Planning Assessment Officer Report

PA2604284 – 440-442
Station Street, Bonbeach

Planning Assessment Officer Report
Development Assessment

Above: Street/front elevation of the proposed building.

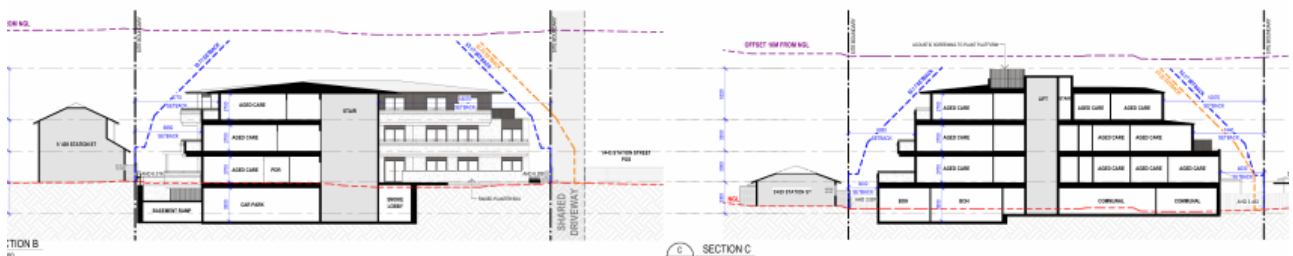
52. Additionally, the proposed building height is to vary across the site, in response to the slope of the land, and will present as a two-storey form with a recessed third storey to Station Street, and a three-storey form with a recessed fourth storey to site's rear interface. The variation in height and recession of upper levels will assist in ensuring the building mass is not unreasonably dominant, particularly in the streetscape context. A streetscape and a render demonstrating the recession of the 2nd floor level is shown below to demonstrate:

Above: Sections with the Clause 53.17 setback line shown in blue.

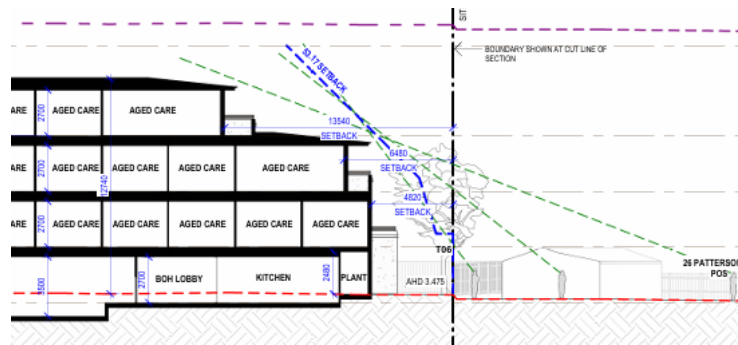
55. The proposal achieves the above by fully complying with the side and rear setback requirement of Clause 53.17 and aside from the basement ramp, no walls on boundary are proposed. This is demonstrated in the following sections:
